CRITICAL ELEMENTS LITHIUM CORPORATION  
**LITHIUM-TANTALUM ROSE PROJECT –  
ANSWERS TO THE SECOND INFORMATION  
REQUEST FROM THE IAAC**  
**IAAC FILE 005327**

DATE: OCTOBER 2020

**Figure 25.1.** Occurrence of tantalum in relation to the concentration obtained after digestion with 4 acids followed by ICP-MS or X-ray fluorescence (XRF) analysis for 4,796 analyzes

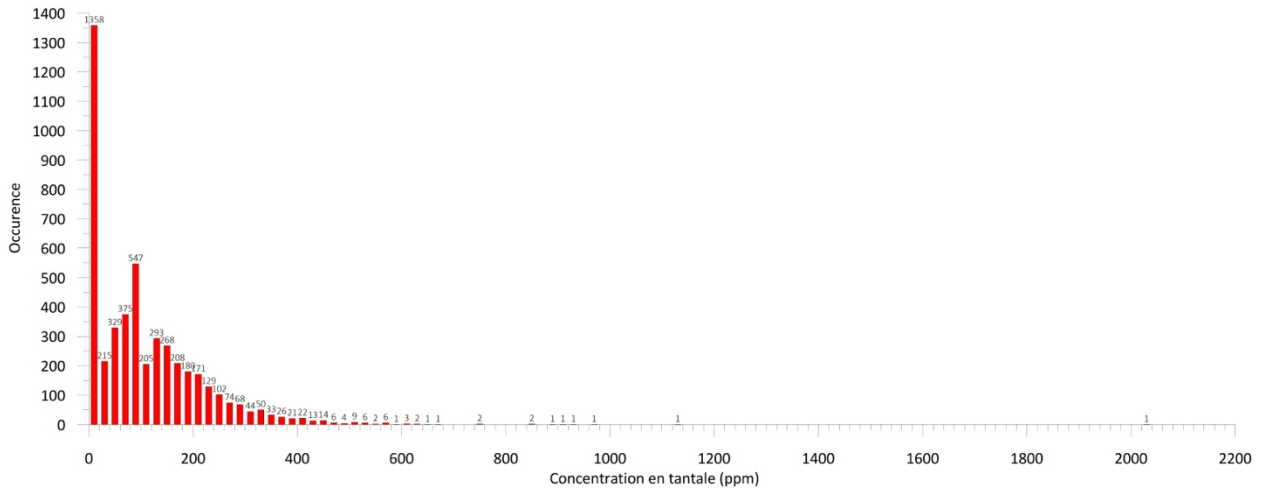
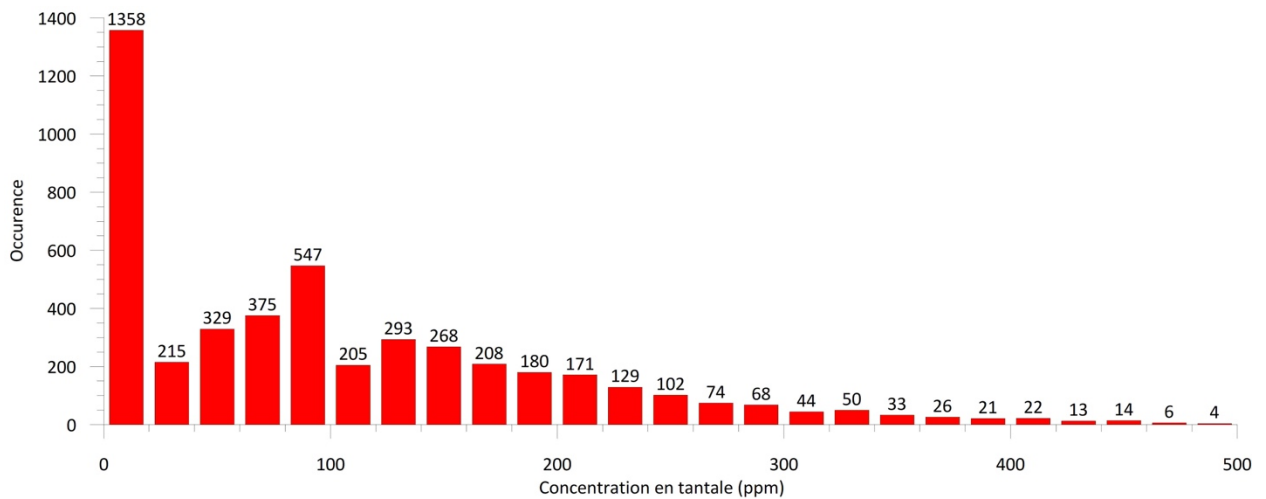
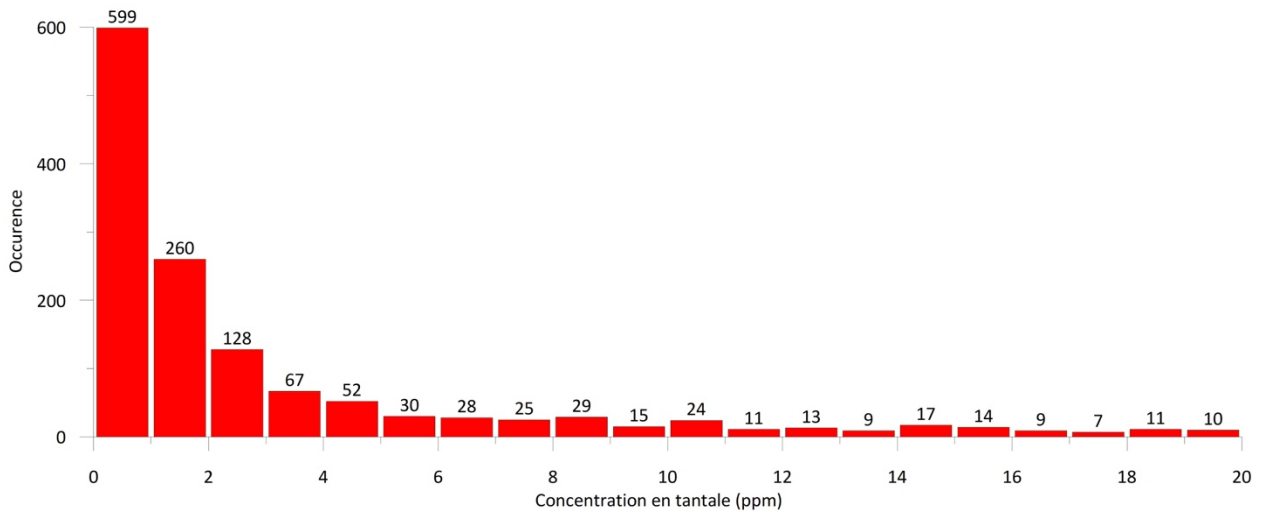
same graphs to derive statistics. Figure 25.1 shows tantalum concentrations in relation to the number of occurrences.

Of the 4796 samples tested, only 41 samples had values greater than 500 ppm. The graph has therefore been redesigned to get a better idea of the distribution between 0 and 500 ppm of tantalum. The result is shown in figure 25.2.

The graph in Figure 2 shows that around 29% of the samples have a concentration of less than 21 ppm tantalum and that there appears to be a second peak around 100 ppm tantalum. We therefore reduced the interval to see the occurrences between 0 and 21 ppm and we obtained the graph in Figure 25.3.

The graph in Figure 25.3 therefore shows that nearly half of the samples from this latter population had a tantalum concentration below 1.4 ppm. If we compare this number back to the initial total population, then we can say that nearly 15% of the samples tested have a concentration of less than 1.4 ppm. This value brings us closer to the probable value of the waste rock that will be deposited on the surface during the mining operation. These are waste rock that would be close to the mineralized zones since laboratory tests were not done on all the drill core but only on the mineralized intervals or in the transition zone (geological contact zone). It is likely that the tantalum concentration for the more distant waste rock is lower.

Figures 25.1 to 25.3 show that there are two statistical populations of rock based on tantalum concentration for the Rose project. The highest population contains a weighted average of 149 ppm Ta, while the lowest population contains an average of 3 ppm.

**Figure 25.4.** Tantalum Test Results for TCLP, SPLP, SFE and CTEU-9 Leach Tests

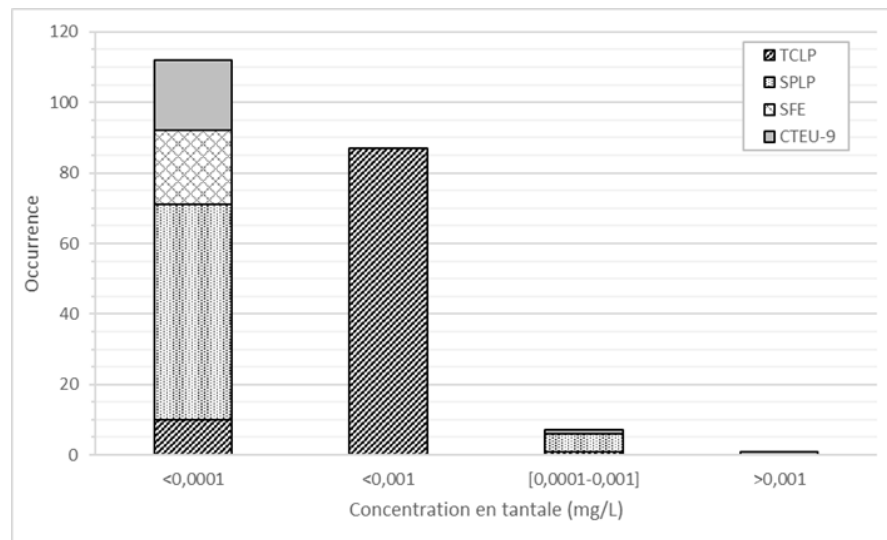
Waste rock and tailings samples were subjected to leaching tests such as TCLP, SPLP, SFE and CTEU-9 during geochemical characterization (Lamont, 2018). Most tantalum concentrations measured as a result of testing were below the method detection limit (Figure 25.4), only a few samples showed tantalum results above the detection limit. Only one sample showed a higher concentration of tantalum and this is a tailings sample submitted to the CTEU-9 test. The measured tantalum concentration was 0.0029 mg/l in the context of this test. It should be remembered that the objectives of the leaching tests are to determine under which conditions elements can be mobilized. The measured concentrations cannot be extrapolated to predict the concentration in the receiving medium. What the tests show is that the tantalum contained in the minerals forming the rocks of the Rose project is poorly soluble and therefore unlikely to end up in the receiving environment.

**Figure 25.5.** Tantalum results for the 13 humid cell tests

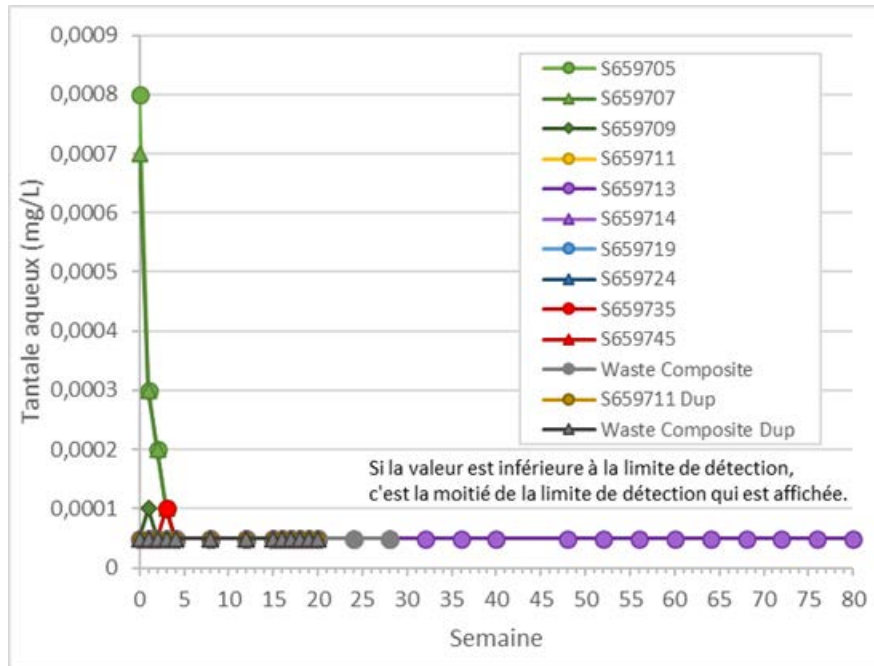
In addition to the leaching tests presented above, kinetic humid cell leaching tests were performed on thirteen waste rock and ore samples. The results for tantalum are shown in Figure 25.5. Most of the results obtained for tantalum are below the detection limit of 0.0001 mg/l. These low values, obtained in a different leaching context compared to the TCLP and SPLP tests, show consistency in the low solubility of tantalum.

However, in Figure 5, two cells containing the mineral showed concentrations as high as 0.0008 mg/l (0.8 µg/l) during the first few weeks. Therefore, a higher short-term leaching of Ta can be assumed from ore or from rock with tantalum concentration in the order of 149 ppm.

In addition to the higher concentrations observed during the first weeks of rinsing, it is observed that the aqueous concentration of tantalum in the humid cells is of the order of less than 0.0001 mg/l (Figure 525.) and is similar to the concentration obtained following a leaching test using the SPLP protocol which is of the order of 0.0003 mg/l. The maximum tantalum concentration observed by the European Union in natural waters is 0.00012 mg/l and by Filella (2017), the maximum is of the order of 0.00018 mg/l. Table 25.2 summarizes the values.

Figure 46.1 : Plant process flow

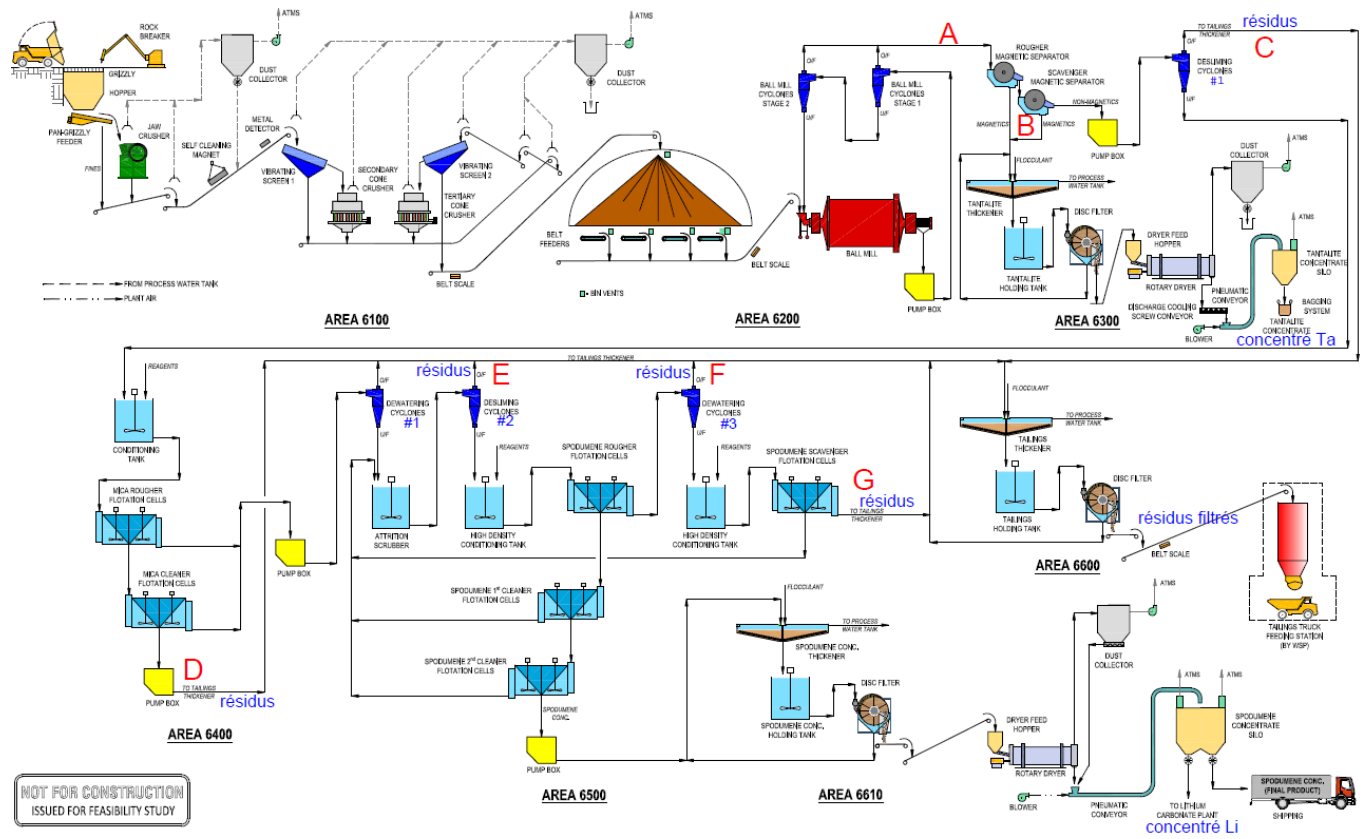
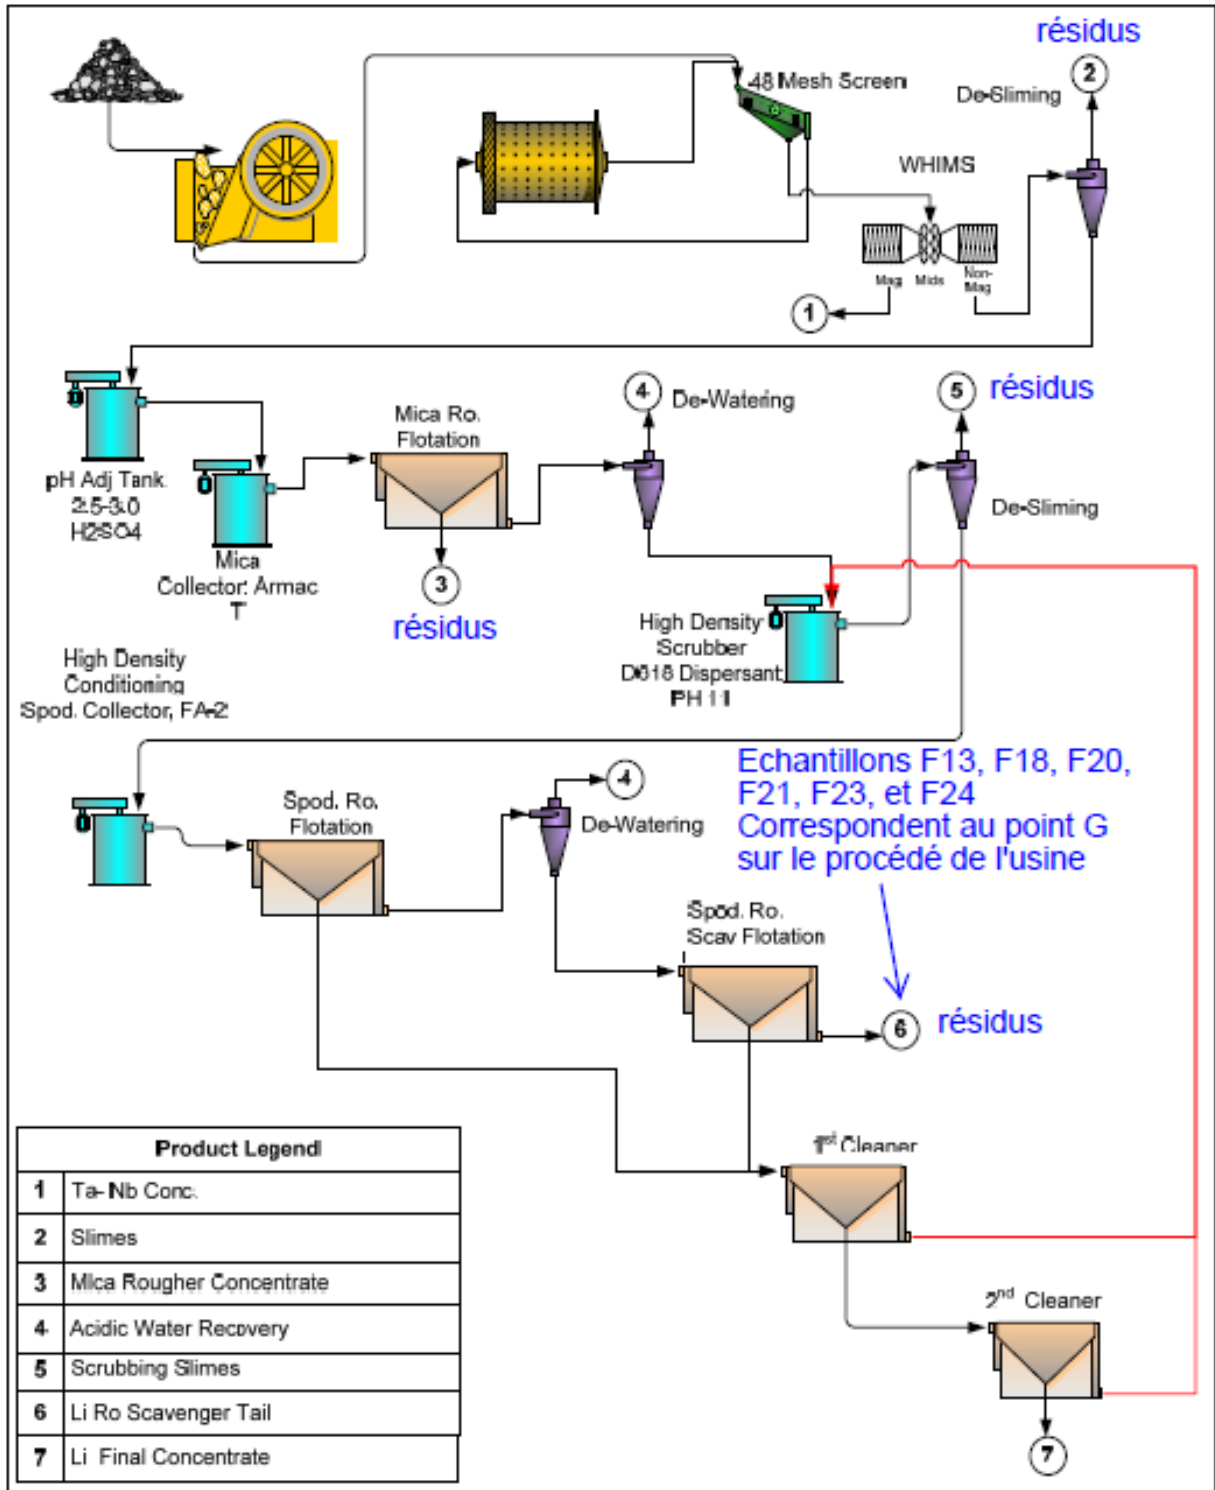
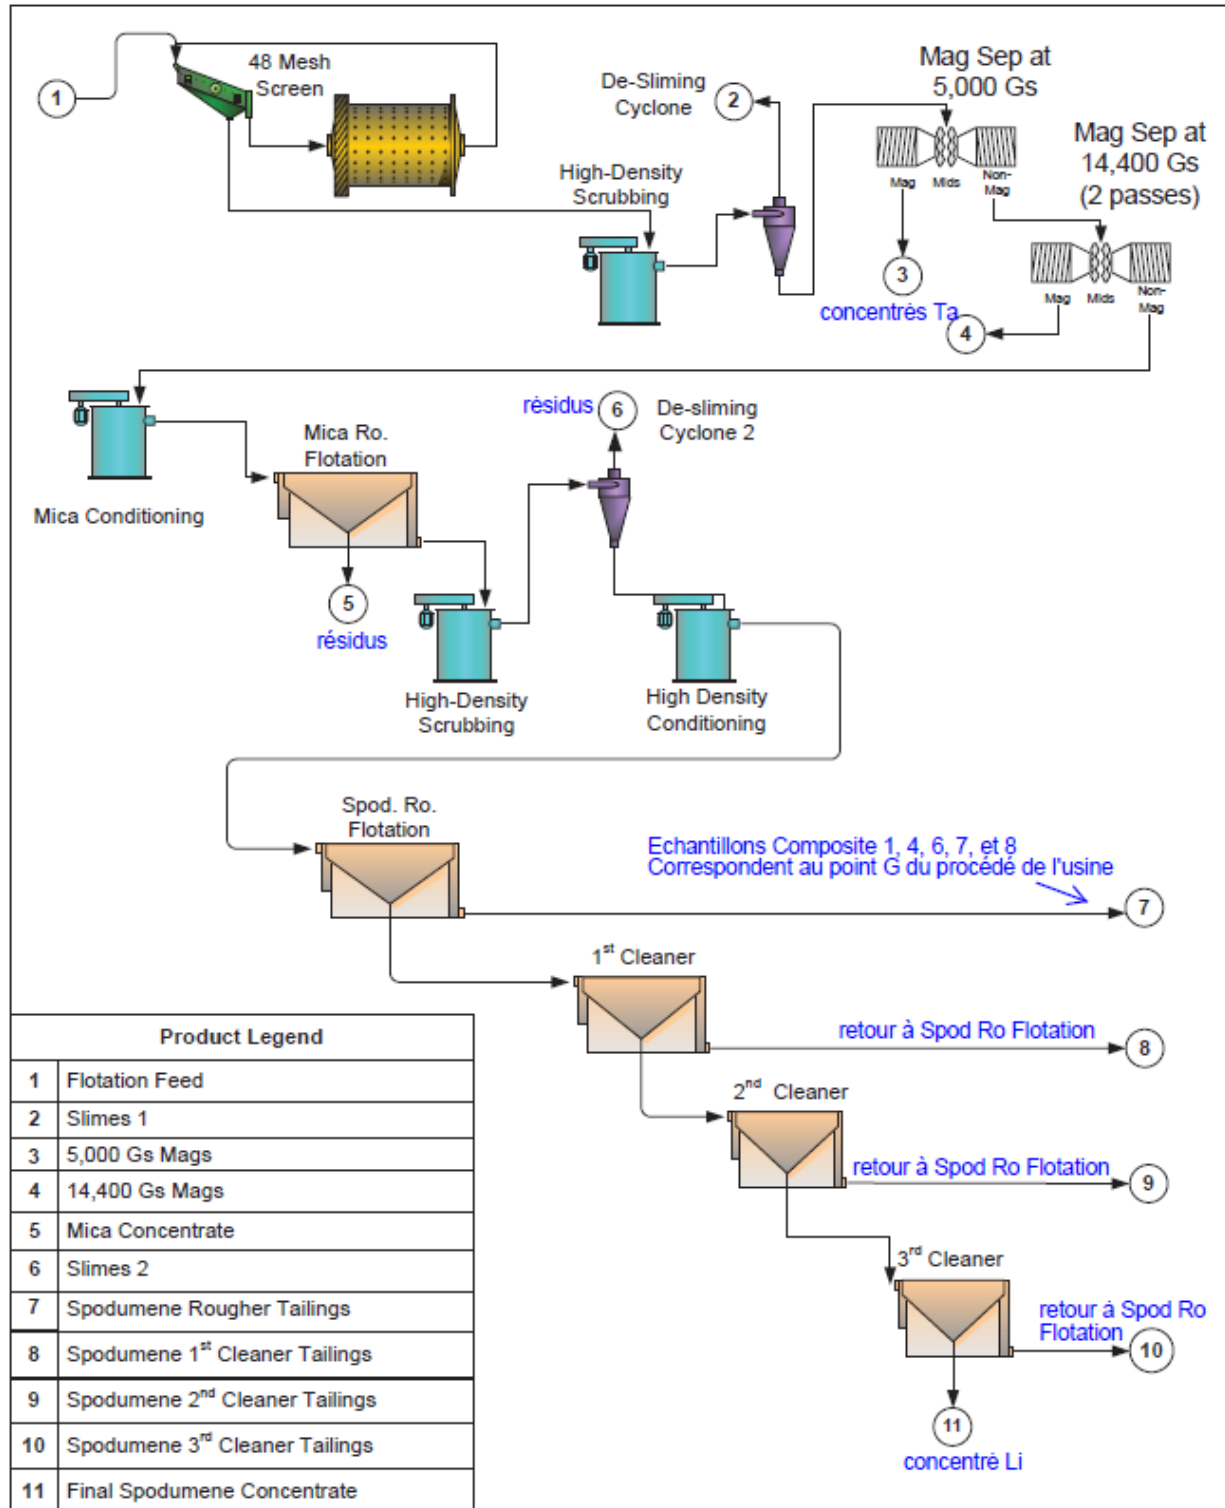
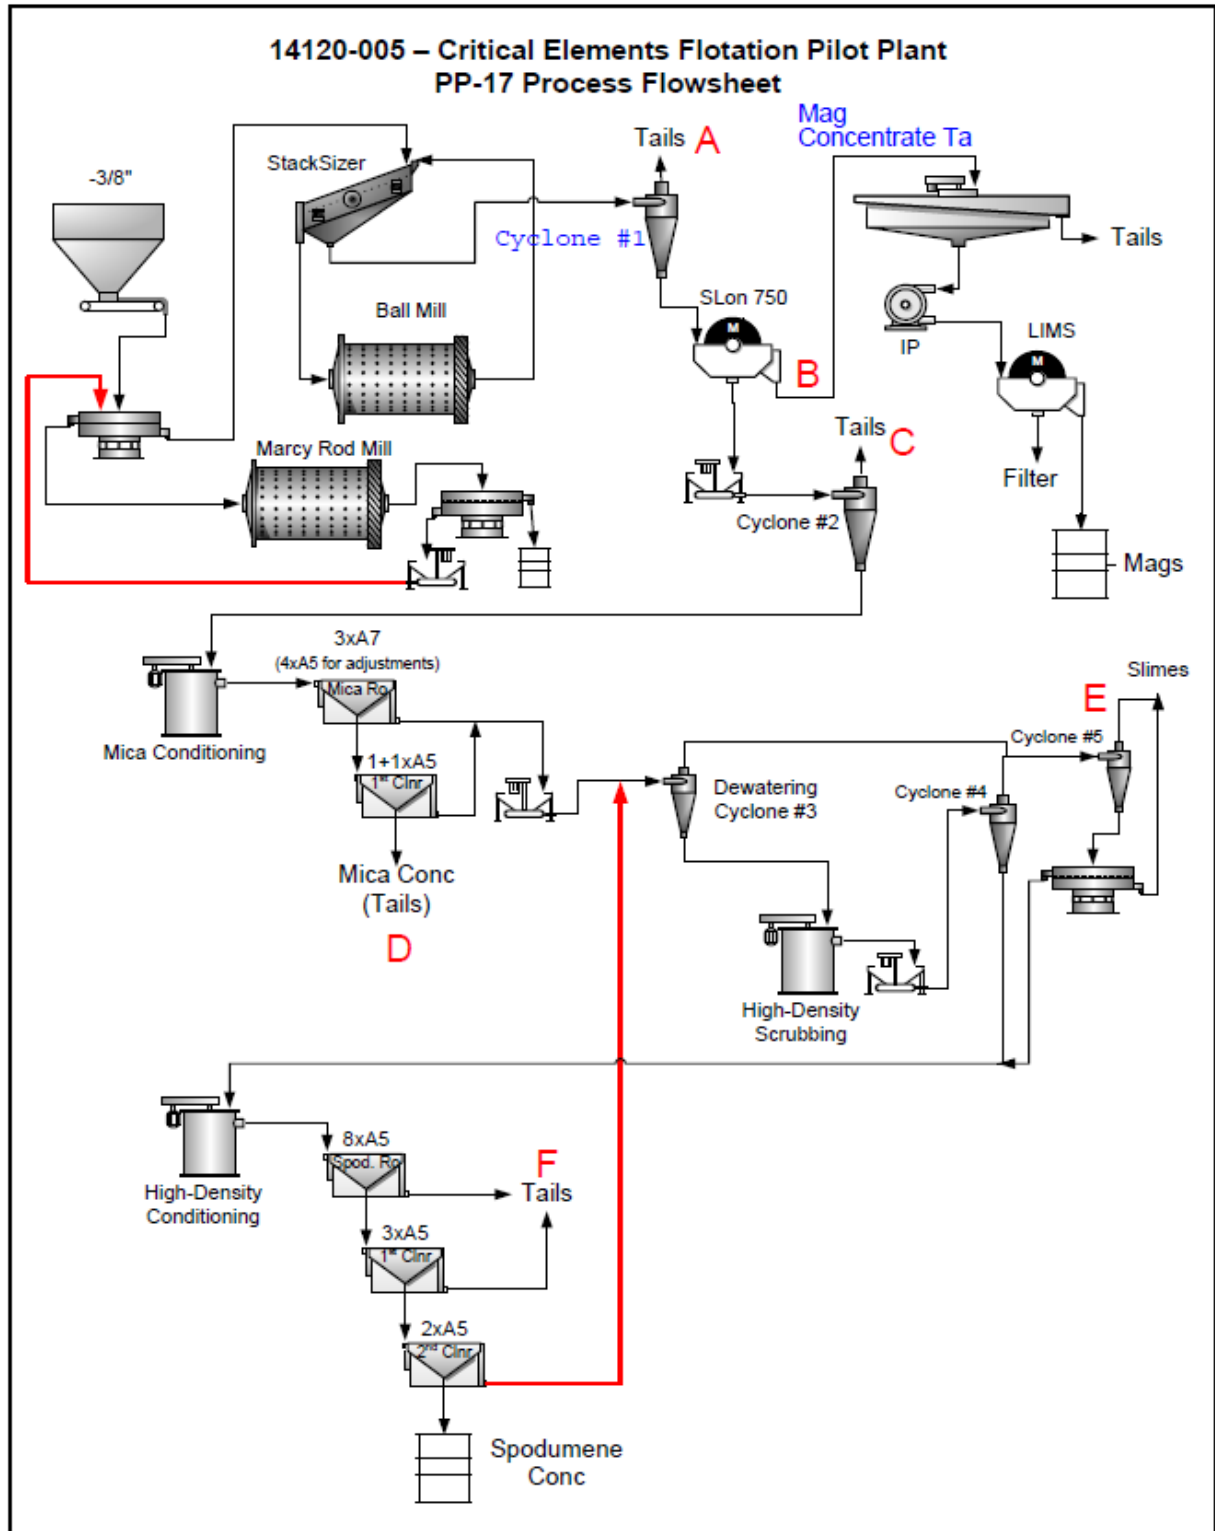
The proponent indicates that the PP17 Comb Tails sample represents all residues generated by the treatment process. In its response to question CEAA-13 C), the PP17 Comb Tail sample is described as consisting of the lithium circuit, mica circuit, and de-flammability residues, which are all generated by the treatment process. Figure 2–3 in Appendix 3-3 of the Environmental Impact Statement (WSP, February 2019b) shows two separate flash stages: one after tantalum recovery and one between mica and spodumene flotation. It is not clear how this sample is produced, including the various steps in the metallurgical process, the inclusion of tantalum recovery and the representativeness of the composition of the thickened residue.

Table 46.1 shows, for each of the residue samples presented in Appendix G of WSP 2019a, the location in the metallurgical laboratory process where it was taken, and the product it represents in the process flow of the process. 'factory. The plant process flow is shown in Figure 46.1. The laboratory process flow for samples F13, F18, F20, F21, F23, and F24 is shown in Figure 46.2. The laboratory process flow of 'Li Ro Tail Composite' samples 1, 4, 6, 7, and 8 is shown in Figure

46.3. The pilot plant process flow for the sample “Thickener Feed PP-17 Combined Tails” is shown in Figure 46.4.
